**Safety of Disposal of Spent Fuel,
HLW and Long-lived ILW
in Switzerland**

**An international peer review
of the post-closure radiological safety assessment
for disposal in the Opalinus Clay
of the Zürcher Weinland**

© OECD 2004
NEA No. 5568

Figure 2: Nagra's procedure for constructing the safety case showing the main elements and the iterative nature of the process [from Nagra (2002a), Fig. A4.1]

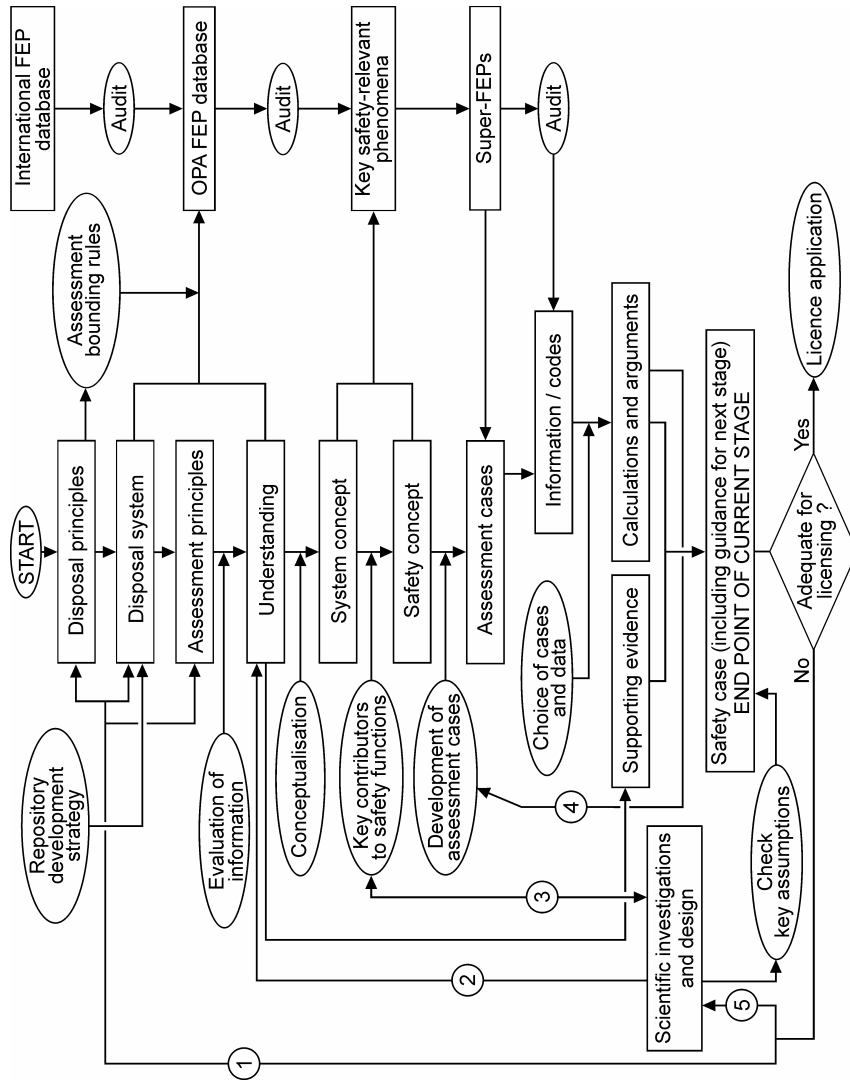
The IRT makes the following observations concerning FEP management for further consideration by Nagra and regulatory authorities.

1. The various tables in Nagra (2002d) set out the uncertainties, related to the Super-FEPs and the safety-relevant phenomena, which have been identified and summarise how they have been taken into account in the safety assessment. It would have been very helpful to the reader if the tables had included references to lower level reports that set out the scientific understanding of the phenomena in question and to the modelling approximations used in the safety assessment. Without such references, one is left with the impression that the tables are used simply to trace the decisions taken and not as part of the iterative process of safety assessment.

2. The assessment cases are based on an understanding of safety-relevant phenomena, including the evolution of the barriers and the associated uncertainties, which in turn draw on input from the Opalinus Clay FEP database (see Figure 2). The safety-relevant phenomena feed into the identification of the Super-FEPs that, in turn, are used as one input to the assessment cases and, perhaps more importantly, as an accounting tool.
